Copier Bulletin: TSB-1078

Models: e-STUDIO1355 Series

Subject: Service Manual Correction – Tray Heaters

Connecting the Tray Heaters of the Main Machine

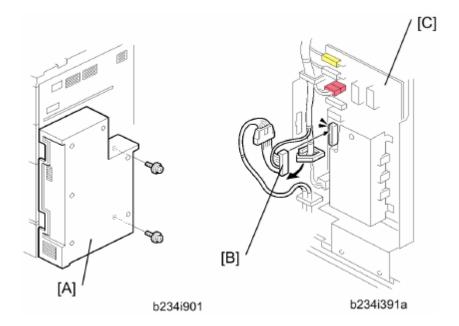
The machine comes from the factory **without** the tray heaters **already** installed **but disconnected**. Tray heater **installation** is optional. The heaters should be connected if the location has high humidity.

Doing this procedure connects the **following** anti-condensation heaters inside the main machine at the following locations:

- One unit below the transfer unit (if installed)
- Two units in the paper tray unit (if installed)
- One unit in the scanner unit (if installed)
- One unit in the LCIT (if installed)

To set the connector

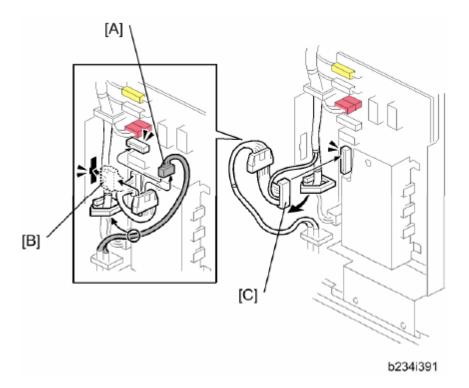
1. Connect the white connector [B] to CN602 on the AC drive board [C].

- Connect the large connector clamped beneath the board.
- This step is not required if the LCIT anti-condensation heater will be connected.
